PUBLIC INTEREST REVIEW FOR GROUNDWATER APPLICATIONS

SUBJECT: Application G- 18006 Supersedes review of \_\_\_\_\_  
Date of Review(s)

**A. GENERAL INFORMATION:** Applicant's Name: Diamond Farms LLC County: Baker

### Water-Level Trends in Nearby Wells

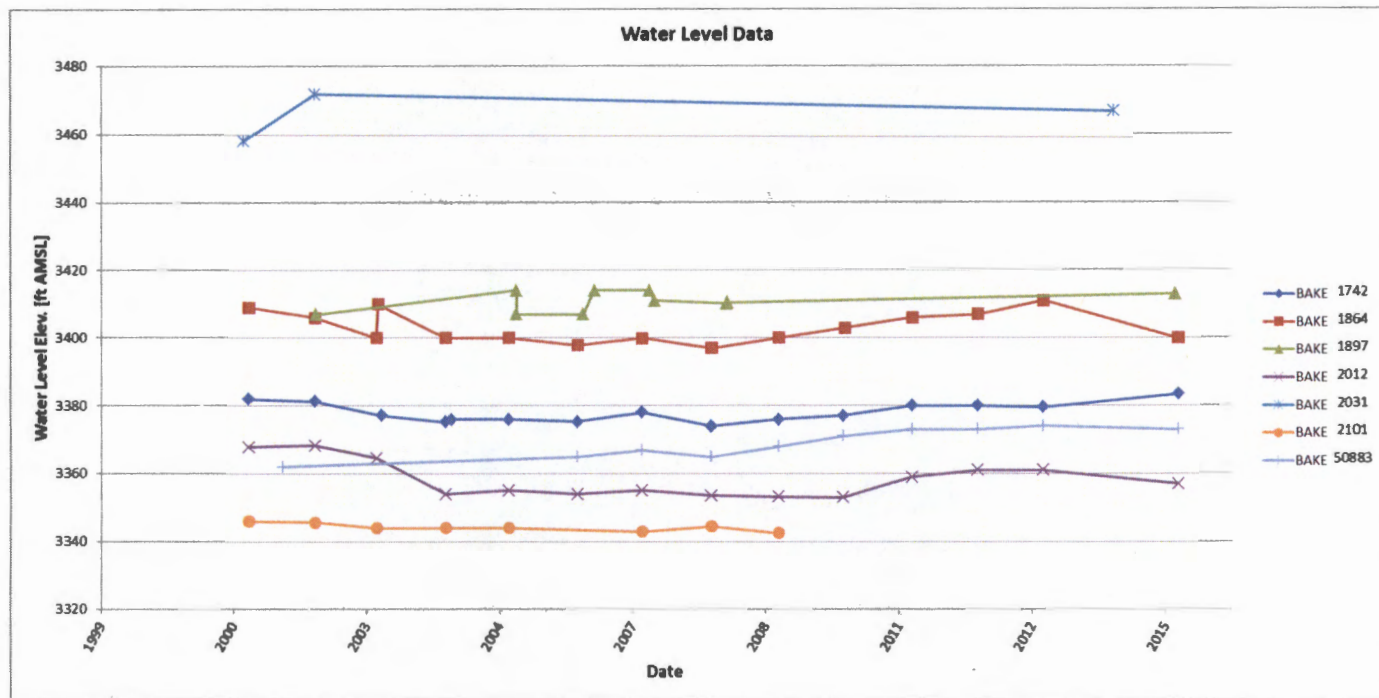
B3. **Groundwater availability remarks:** Groundwater elevations in wells within several miles to the west of the proposed POA location have remained stable since the year 2000 (see attached). These measurements were made in wells producing from alluvial wells in which basalts or other volcanic units were not encountered and so may not represent the same aquifer system as proposed on this application. The proposed POA location is within 200 feet southwest of the mapped contact with Tertiary basalt (Tb) of Brooks and others (1976) on the northeast side of a fault. Wells within 1 mile have encountered volcanic units at very shallow depths on this side of the fault (see attached log for BAKE 51823).
